CONVERTING HONEYWELL GAS VALVE TO SIT VALVE

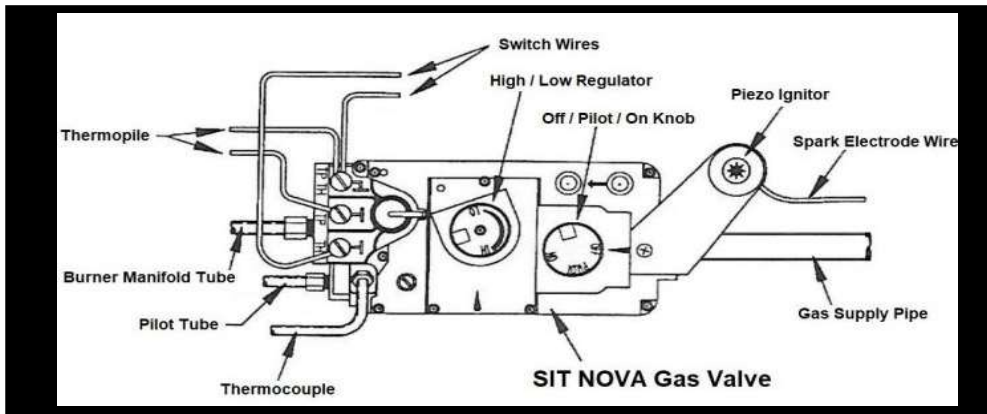
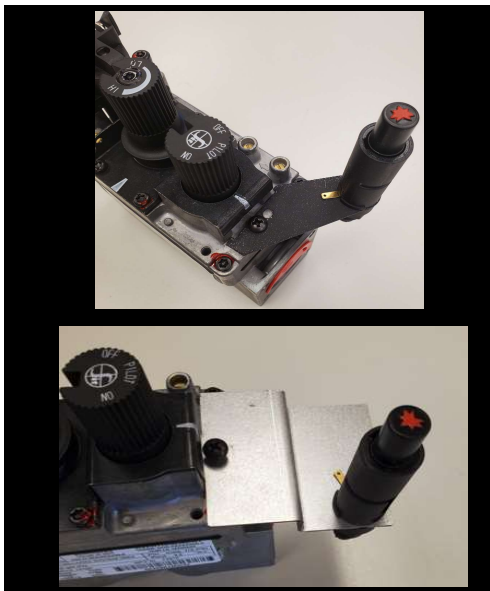
Some field modification may be necessary w/bracket and gas connections.

IN-----OUT
Arrow shows direction of gas flow.
New SIT valve may need to be installed
in different position than original
Honeywell valve. Installing new valve
backwards will cause damage to valve.

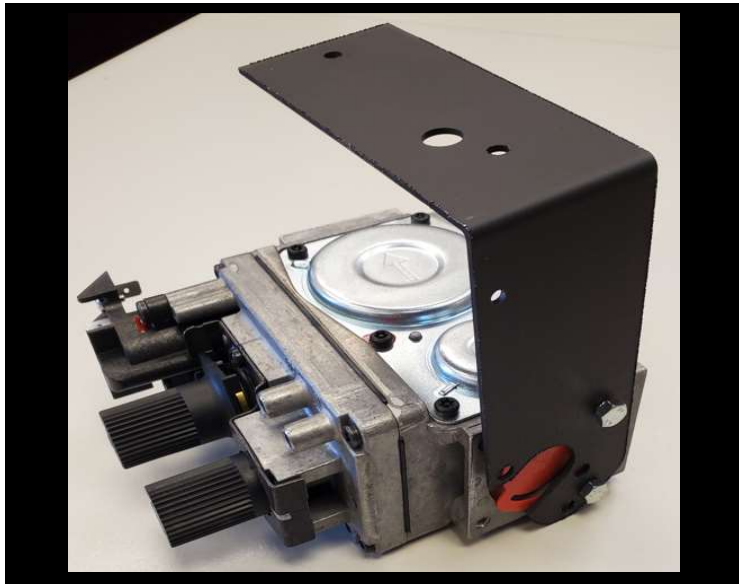
Thermocouple has 2 possible locations on the new SIT valve. The preferred is position 1 and will come configured for that position. This will provide easy connection at time of install & if future service if needed. If your original valve the thermocouple installed in the rear part of valve (position 2), simply stretch out the thermocouple wire and connect to position 1.
